**MANDATORY BULLETIN No. EV 97 – 002a**  
**P-220 UL – 002a**

1. **REFER TO :** Ultralight airplanes EV-97 EUROSTAR S/N 9700X2, 9700X3, 980101-980106, 980202-980206, 980301-980304, 980306 and P 220 ULR S/N 96007486, 960003, 960005, 970006, 970009, 970102, 970104, 970105, 970107-970113, 980114-980120

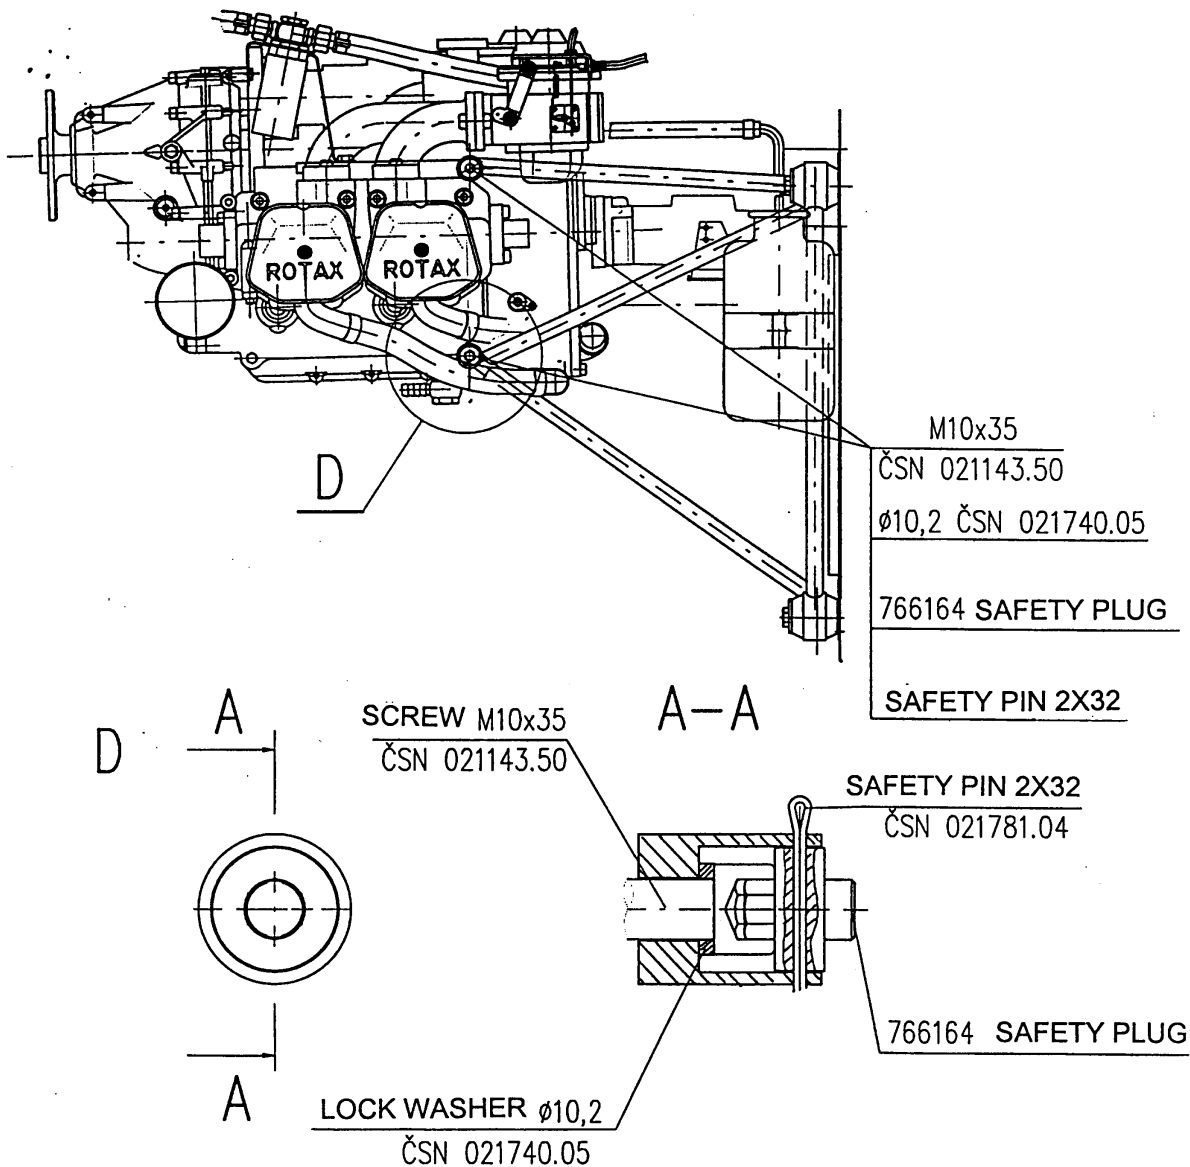
2. **REASON :** A loosening and consequent deformation of the lower left engine-engine bed attachment screw has been detected during operation of the EV-97 EUROSTAR aircraft.

3. **REQUIRED ACTION :** Carry out the check of the engine-engine bed attachment screws. Follow the Operating sequence tasks described in the Enclosure if you find a deformation or other damage of those screws. If there are flat washers under the screw heads, replace them by the lock ones. The flat washers were found as unsuitable.

Remove the safety pin, loose and remove the lower left engine suspension screw (supporting engine is recommended to unload the screw).

Visually check the screw for condition, deformation, and damage. When you found defects replace the screw by a new one supplied by the manufacturer on your request. The lock washers 10.2 ČSN 02174005 must be under the screw head. If flat washers are installed under the engine suspension screws, replace them by the lock ones supplied by the manufacturer on your request. Tighten the screw(s) using a torque wrench (torque moment 44 N.m) after replacement, secure with safety pins.
